Re: **Modification No. 5 to the Remedial Design Report/Modification No. 3 to the Leaching Analysis Report**
Increase in Thickness of Waste Rock Fill in Central Valley Area to 75 Feet
Three Kids Mine, Henderson, Nevada

To: Alan Pineda, Nevada Division of Environmental Protection
From: Karen Gastineau, Broadbent & Associates, Inc.
Subject: Modification No. 5 to the Remedial Design Report/
Modification No. 3 to the Leaching Analysis Report
Increase in Thickness of Waste Rock Fill in Central Valley Area to 75 Feet
Three Kids Mine Site, Henderson, Nevada
Date: January 17, 2025

Increase in Thickness of Waste Rock Fill in Central Valley Area

Attachment 3
75-foot Waste Rock Model

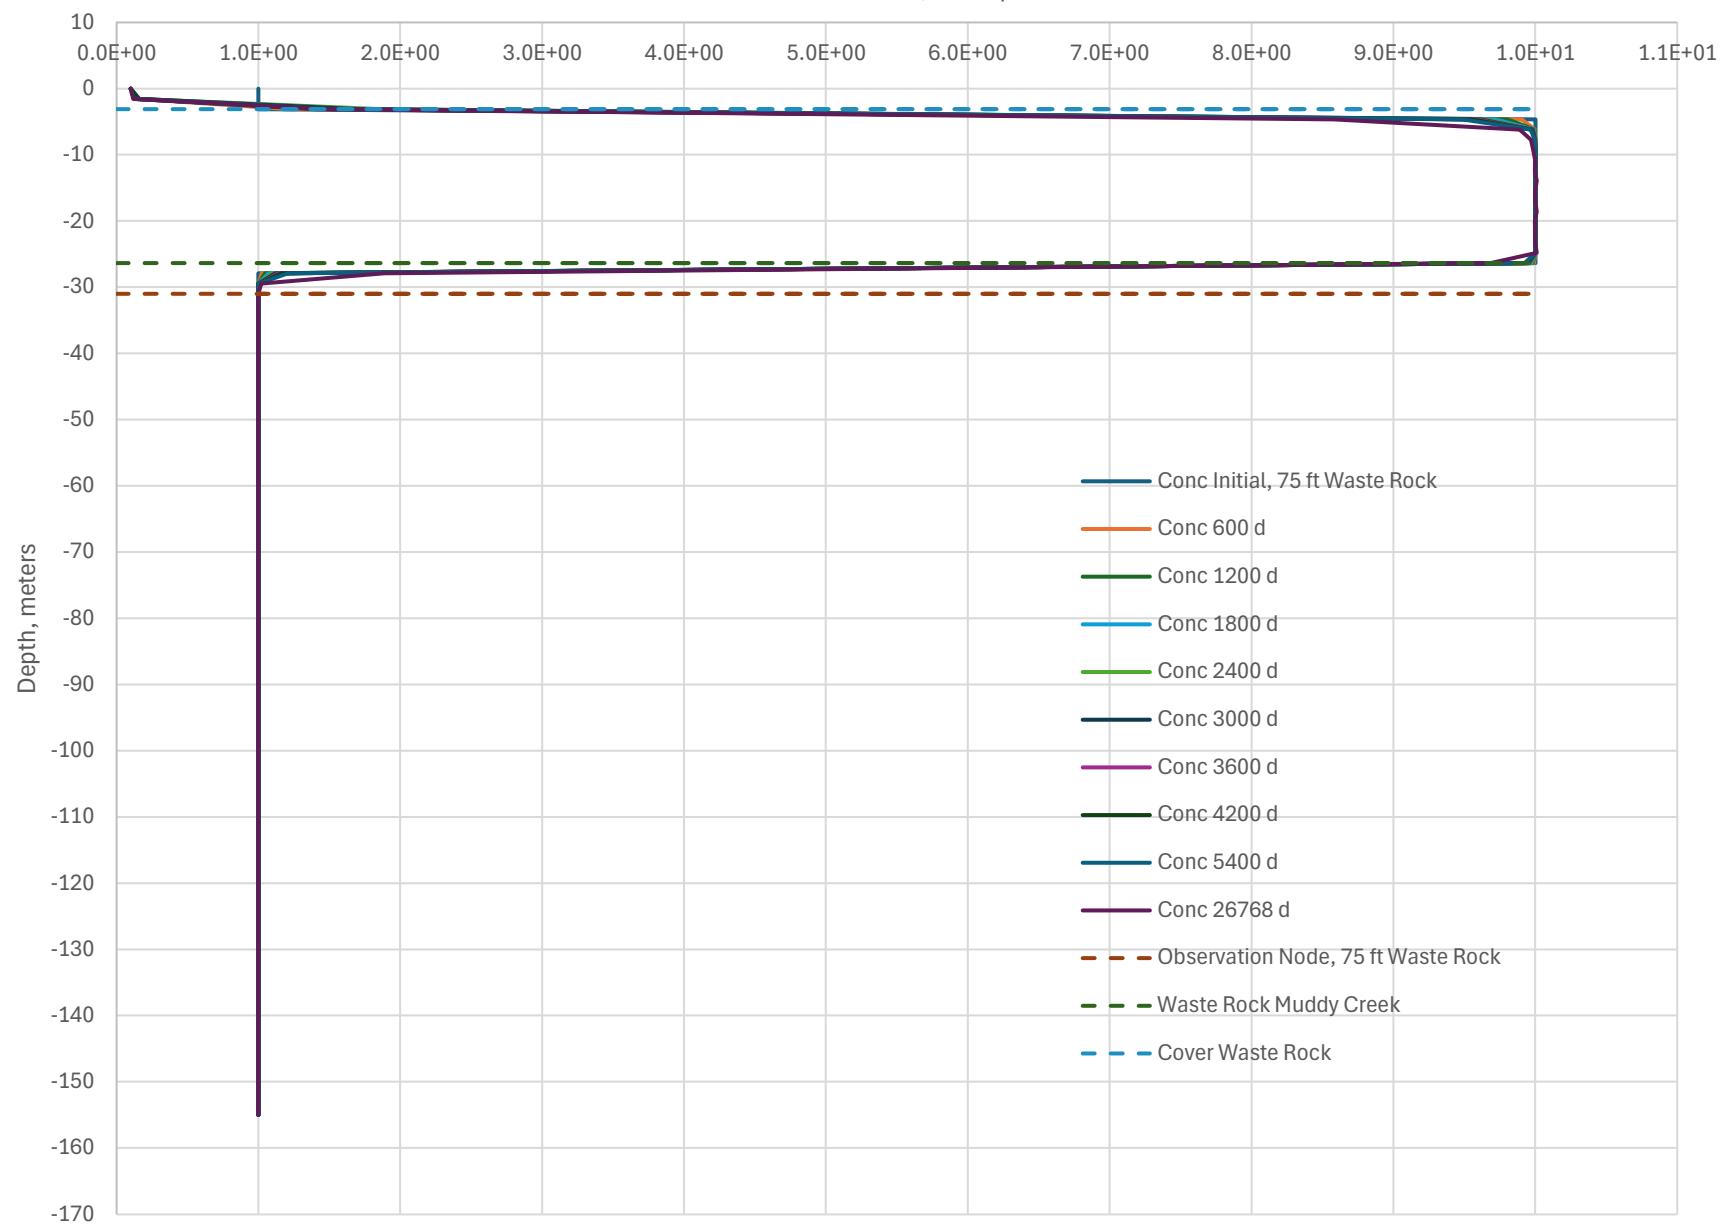
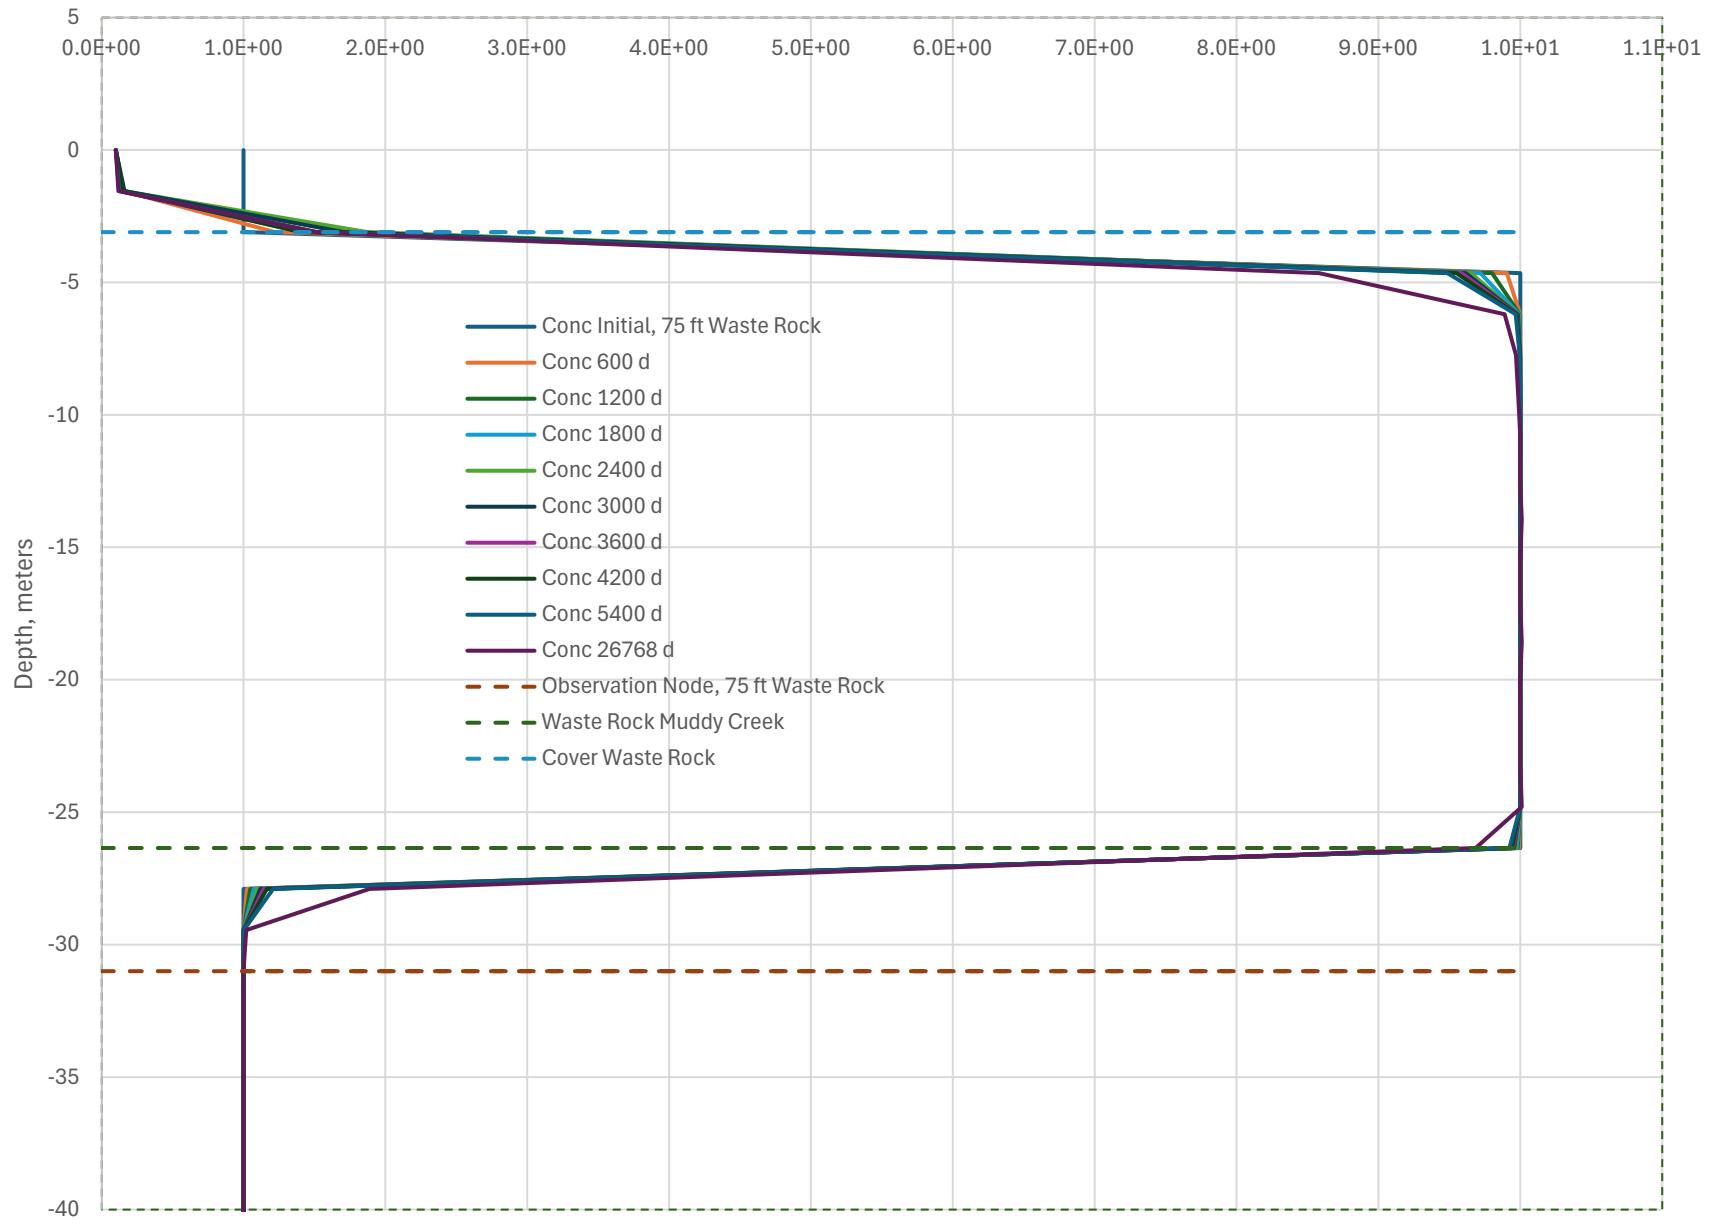
EA Engineering, Science, and Technology (EA Engineering) remodeled the CVS based on a cross section with 75 feet of waste rock fill plus 10 feet of cover. Results indicate that the increase in waste rock thickness would not have an adverse impact on groundwater. Additional details on the remodel are provided below. If approved, this modification would allow for waste rock fills up to 75 feet thick in the Central Valley Area.

EA Engineering analyzed the effect of waste rock thickness on infiltration and drainage past the root zone and contaminant migration through supplemental numerical modeling with Hydrus software. The CVS base case model domain in the Leaching Analysis (Broadbent 2022) was modified to include 75 feet of waste rock fill beneath the alluvial 10-foot cover and on top of the Muddy Creek Formation. This represents a 15-foot increase in the thickness of the waste rock fill over the previous simulation, which had a 60-foot-thick layer of waste rock in the model domain. The change in waste rock thickness is significant because waste rock has elevated arsenic concentrations relative to the cover material and Muddy Creek Formation. Additionally, the increased waste rock thickness increased the depth of the

Similar to the 60-foot waste rock simulation, the 75-foot results are not significantly different than the original simulation of 40 feet of waste rock. The changes in predicted concentrations are minor, and rather than picking concentrations from the Hydrus output graphs, which are low resolution and the method of presenting results in the base case model, the numerical model output in the attached tables was compared to eliminate interpolation between model nodes in the graphical output. At the low concentrations predicted by the model, considering the numerical output provides more accurate predicted results and comparison of the scenarios which are currently being evaluated for reclamation performance.

Estimated travel times from the base of waste rock fill to groundwater are not appreciably affected either: the calculated travel times for infiltrating water through the waste rock/Muddy Creek Formation contact to groundwater for 40, 60 and 75 feet of waste rock fill are 763, 671, and 640 years, respectively. The reduced travel times are related to reduced distance to groundwater resulting from thicker fills: the top of elevation of fill is fixed by the grading plan. The difference in travel time between 40-foot fill and 75-foot fill is 123 years, which is a 16.1 percent relative change. The results of supplemental unsaturated flow and contaminant transport modeling demonstrate that increasing waste rock thickness in the CVS reclamation design from 40 to 75 feet will not impact the waters of Nevada.
